Memo

Re: Ord. 35-15 - Rezoning approximately 152.2 acres from R, Rural District and R-1, Restricted Suburban Residential District to PUD, Planned Unit Development District for the potential development of the site with up to 185 single-family lots and approximately 76 acres of open space on the west side of Avery Road, north of the intersection with Belvedere Green Boulevard under the provisions of Zoning Code Section 153.050 and a preliminary plat for 185 single-family lots, rights-of-way, and open space in accordance with Chapter 152, the Subdivision Regulations (Case #14-068Z/PDP/PP).

Ord. 36-15 (Amended) - An Ordinance Authorizing the City Manager to Enter Into An Infrastructure Agreement with Davidson Phillips, Inc. for the Riviera Development

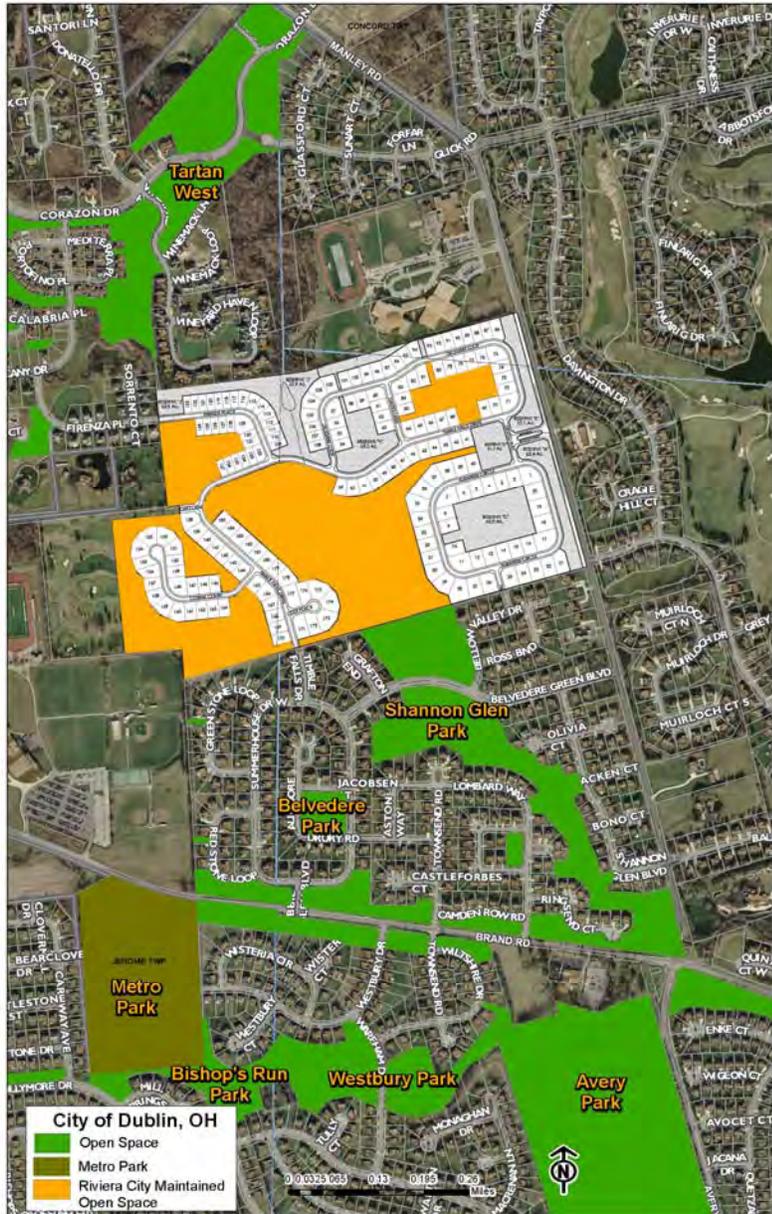
The applicant has revised the development text and the preliminary development plan to address some of the requests by Council. To preserve the trees on Lot 41, the applicant has decreased the size of Lots 30 through 40, as they exceeded 100 feet in width in the previous plan.

The revised lots still meet the text requirement of 100-foot lots within this Subarea but allow the location of Lot 40 to adjust away from the trees. A lot was relocated between Lots 86 and 93 to adjust the location of Lot 41. The revised plan continues to show 185 lots on the 152.2-acre site for an overall density of 1.22 units per acre. The lot relocation also adjusted the distribution of open space, however, the overall number remains the same at 76.1 (50%).

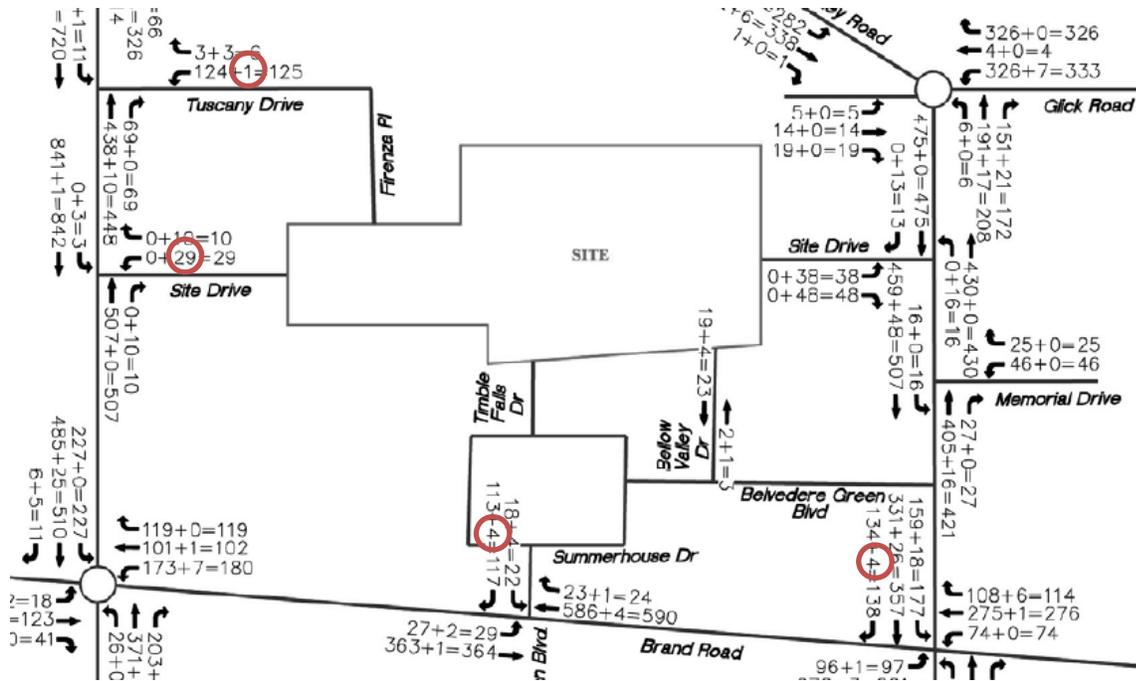
In the diagram below (2024 AM Peak Hour – Full Build) from page 15 of the traffic study, the traffic counts anticipated from the new development making movements that would indicate potential trips to Dublin Jerome High School will total 38 trips.

As noted in the diagram above, ambient traffic from the existing Belvedere subdivision of 154 homes generates 113 right turns from Abbie Glenn Blvd onto Brand Rd heading towards Dublin Jerome High School at the southern exit of the subdivision. It is not reasonable to assume that a subdivision of 154 homes generates 113 trips while a subdivision of 247 homes will only generate 38 trips.
